SUBJECT: SAVANNAH RIVER SITE HIGH LEVEL WASTE TANK CLOSURE:
CLASSIFICATION OF RESIDUAL WASTE AS INCIDENTAL

U.S. NUCLEAR REGULATORY COMMISSION
REVIEW OF THE DEPARTMENT OF ENERGY AT SAVANNAH RIVER
HIGH-LEVEL WASTE TANK CLOSURE METHODOLOGY

Figure 2: General layout of F-Area Tank Farm [2].

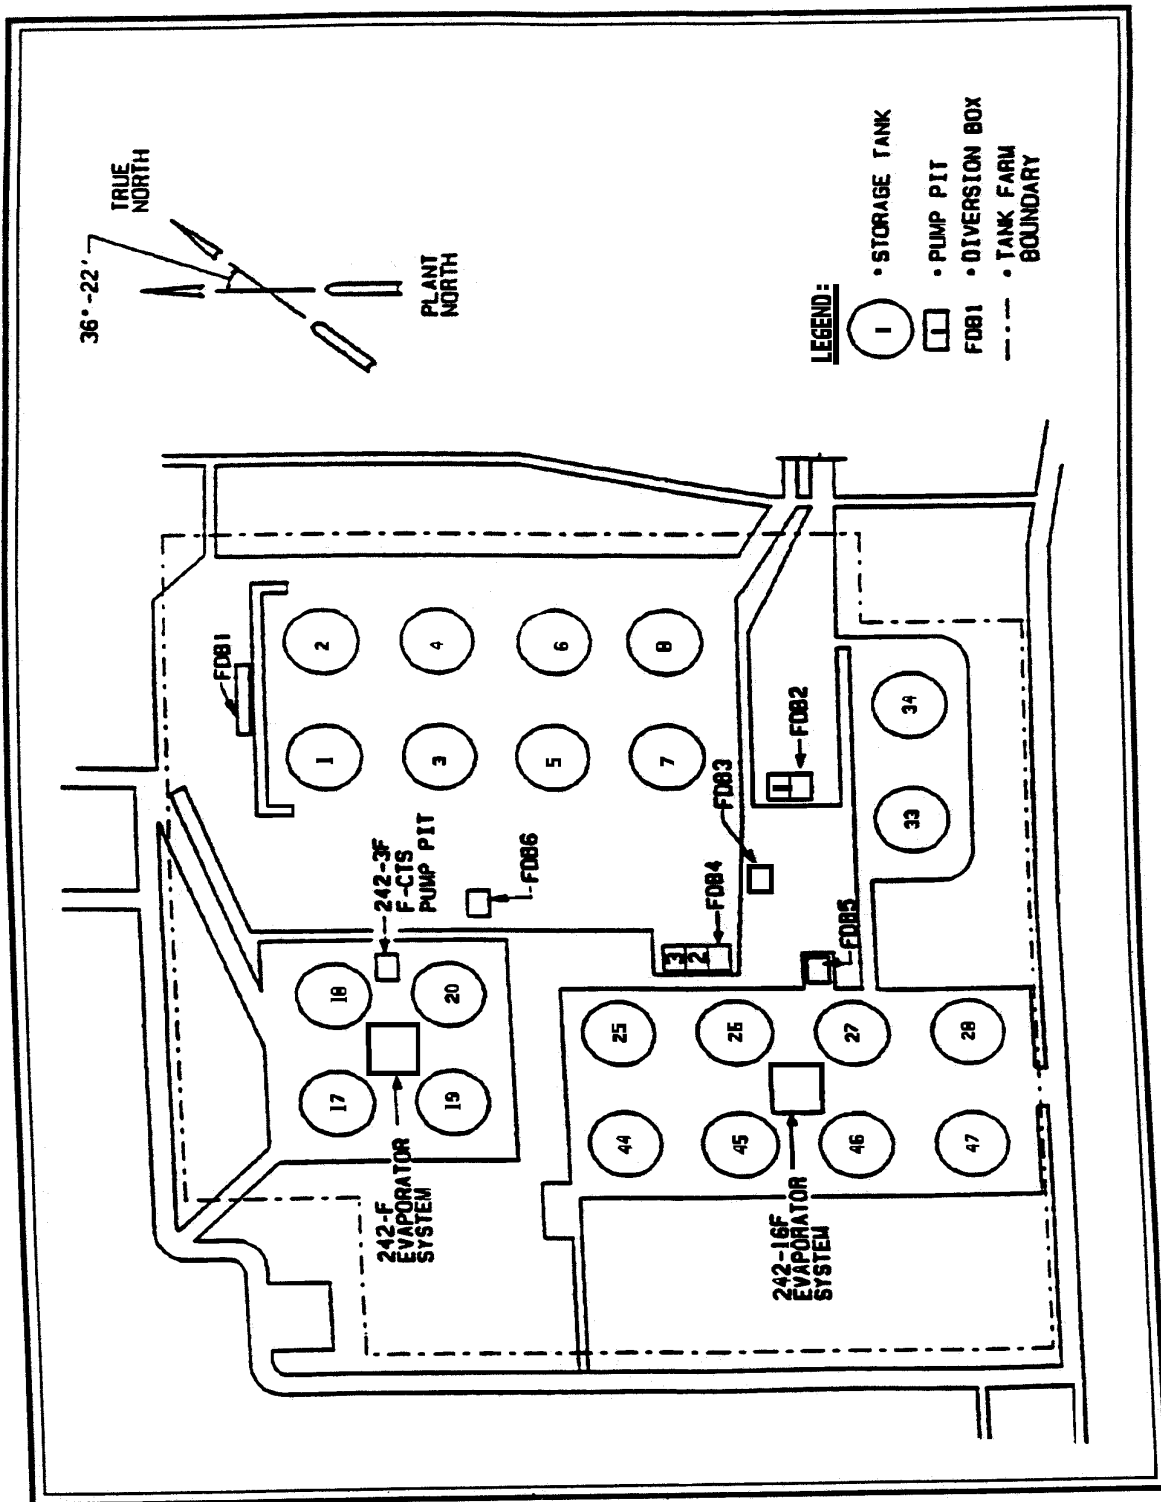
One tank group (17-18-19-20) in F-Area Tank Farm is located just above the water table. At times, these tanks may become partially submerged due to seasonal fluctuations of the water table. Some tanks in the H-Area are also in or near the water table. Partially submerged tanks may affect the manner that MEPAS models the release and transport of radionuclides. For tanks where the contaminated zone is beneath the water table, the release may be dominated by the horizontal flux of water rather than the vertical flux of water one would usually assume for tanks in the vadose zone. DOE attempted to show that the most conservative manner to model submerged tanks is to use the base case vertical flux model. Due to the small projected cross-sectional area perpendicular to horizontal flux the release rate is greatly limited. This is characteristic of the MEPAS code, and may be non-conservative, as changes in volume do not change leach rate estimates for the unsaturated zone leach rate model.

Future PA studies should model all submerged tanks or tanks within the fluctuating water table as submerged tanks, using a physically based geochemical and fluid transport leachate model, since the MEPAS code does not conservatively model submerged tanks. The release rate model for MEPAS uses only cross-sectional area and the radionuclide concentration to determine rate of release. Future modeling needs to consider the effects of increasing the volume of waste, and should include a shorter expected life time for the grout, due to submersion.

Figure 4: Tank closure showing layers of fill material [5].

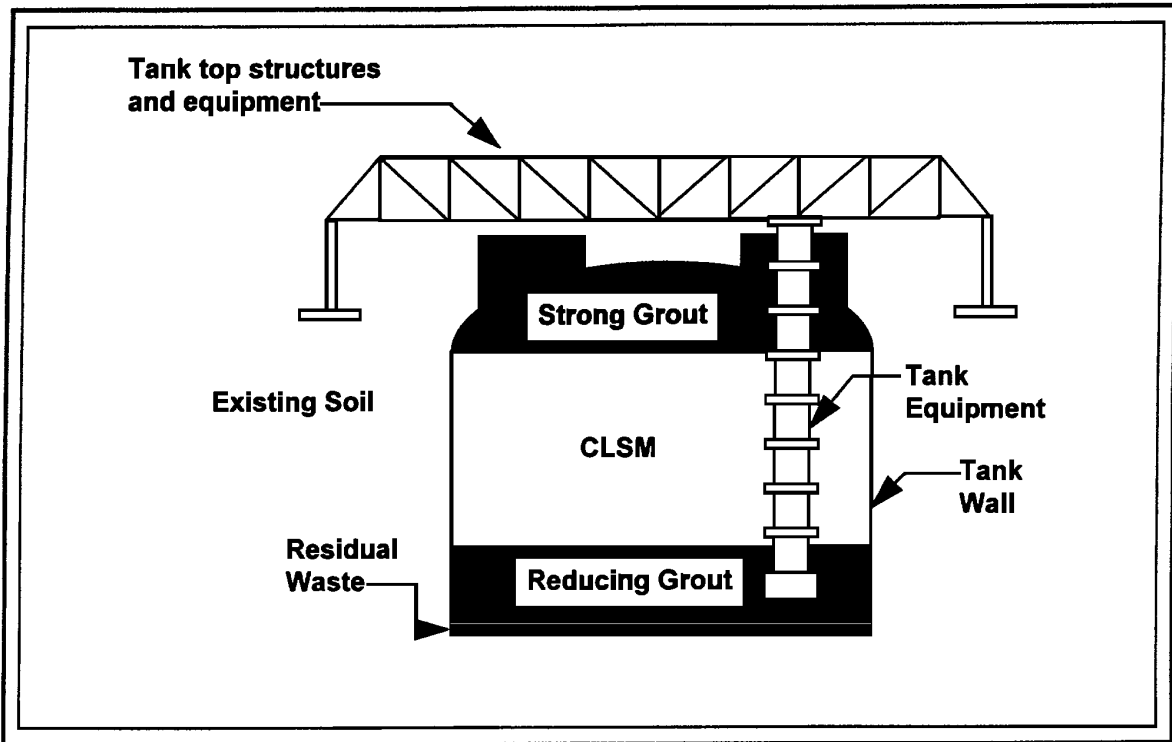
We reviewed the DOE Closure Plan [2], the Regulatory Basis [5], the actual grouting procedures used in Tanks 17 [6] and 20 [16], and the CTL report [13], to evaluate the solid physical form portion of this criterion. We also reviewed additional information provided in the form of photographs of the CTL reducing grout test pours, cylindrical samples taken from solidified test pours, and videotapes of the grout pours. The filled tanks are expected to provide a stable waste form.

- The filled tanks will provide an acceptably stable waste form in conformance with the structural stability requirements of 10 CFR 61.56(b)(1).
- Application of the BTP on Concentration Averaging is an acceptable means of meeting the waste classification criteria of Part 61, but is not applicable for all tanks.
- DOE's request that NRC apply the provisions in 10 CFR 61.58, for alternative considerations for classification of waste, will be evaluated based on the performance objectives of 10 CFR 61.40 (Criterion Three). If Criterion Three is met, the requirements of Section 61.58 are satisfied; however, use of alternative considerations under Section 61.58 to meet Criterion Two of the Incidental waste criteria must be approved by the Commission.
